Shafi Knit Ltd.

12th May 2019

Structural Inspection Report

Observations & Actions

Typical floor beam layout

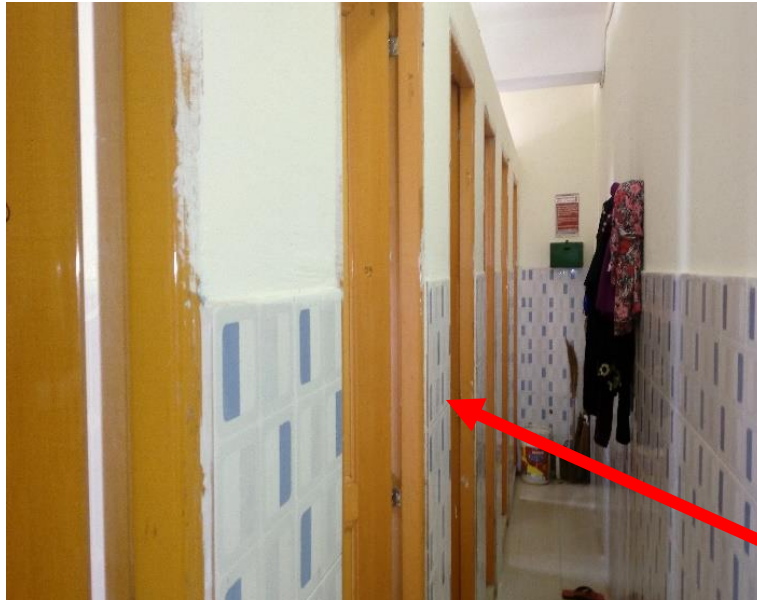
Cantilever beam on roof floor beam

Cantilever beams were found only at 3rd floor roof. A Typical Floor Beam Layout Plan shows cantilever beams. In addition, beam down stand was measured 200 mm instead of 250 mm (as per provided as-built drawing) at 1st to 3rd floor beams.

- Building Engineer to survey the structure and prepare accurate as-built drawings.

Toilet Zone

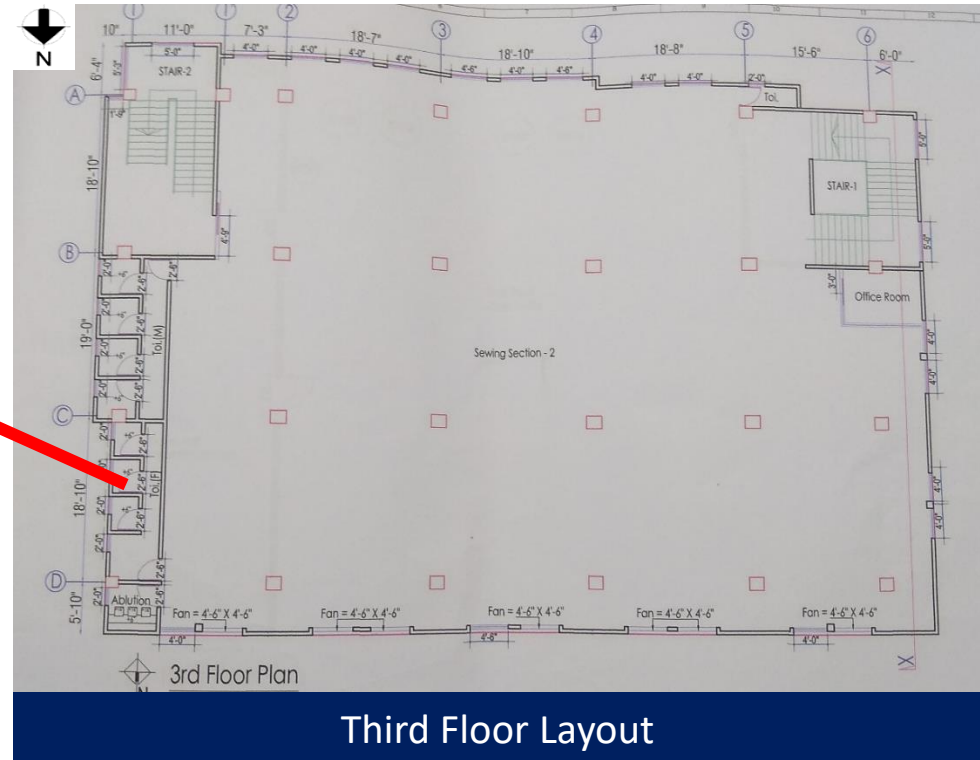
Number of toilets did not match with as-built drawings. Six nos. of female toilets were found on site where as-built drawing shows three nos.

Significant gap between steel baseplate and RCC column of Shed-1

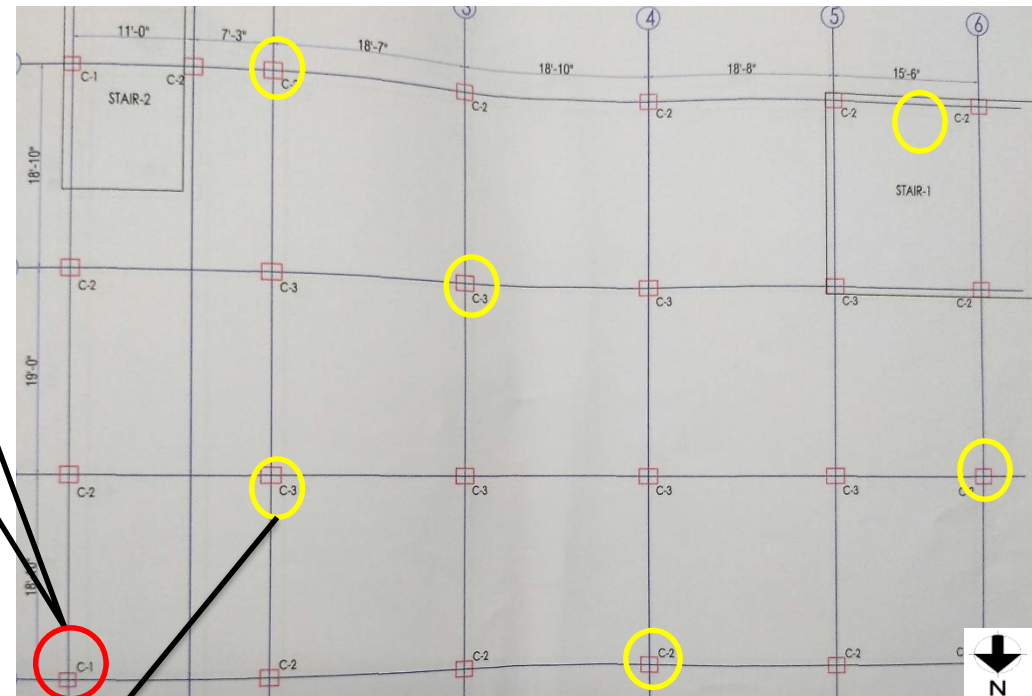
Significant gap observed between steel baseplate and RCC column.

Poor/non-engineered connection was found at extension of shed-1 (doctor's room)

- Check the adequacy of the connections.
- Carry out suitable remedial works as per suggestion of factory engineer.
